# 1979 Corvette: Service News: Corvette Auxiliary Cooling Fan Wiring Revision

**Subject:** Corvette Auxilliary Cooling Fan Wiring Revision

**Model and Year:** 1979 Corvette Equipped with 5.7L (350 Cu. In.) V-8 RPO L82 and Air Conditioning

**Source:** Chevrolet Service News

Fig. 4 — 1979 Corvette Auxiliary Cooling Fan Wiring Diagram

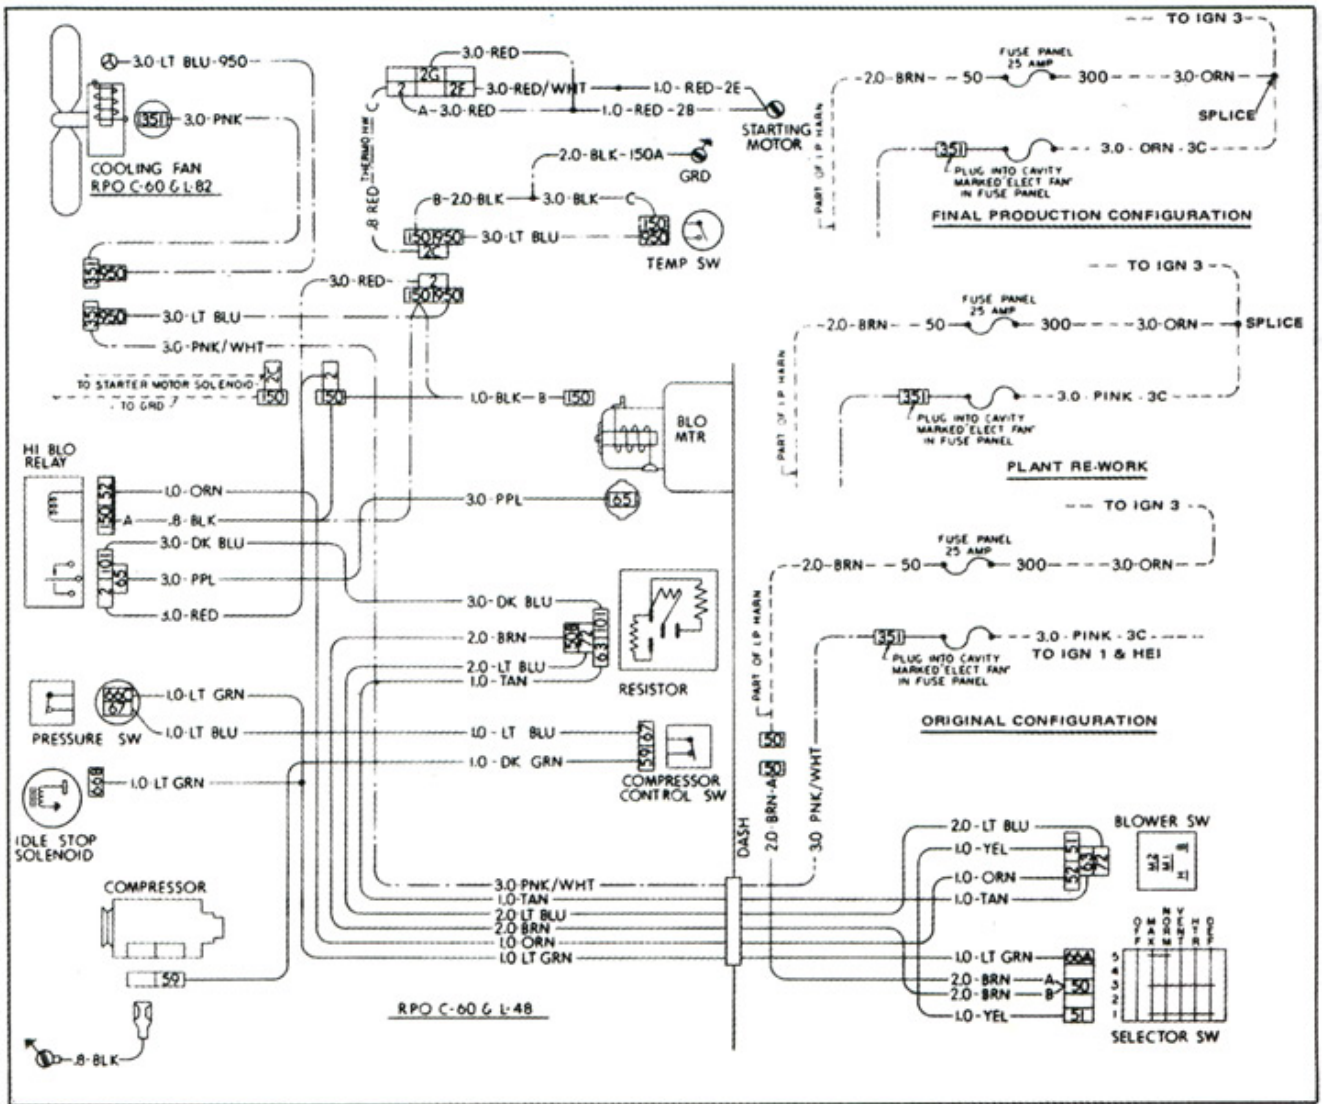
During early production, it was discovered that non-powered rundown of the fan motor generated a voltage sufficient to maintain ignition after ignition switch shut-off. This could result in a momentary engine run-on condition similar to dieseling.

To eliminate any run-on, the assembly plant began re-working the instrument panel wiring harness, effective with VIN 1Z8749S402690, as shown in the wiring diagram (see Figure 4). A final production revision to the harness (see diagram) will be phased into production as soon as possible.
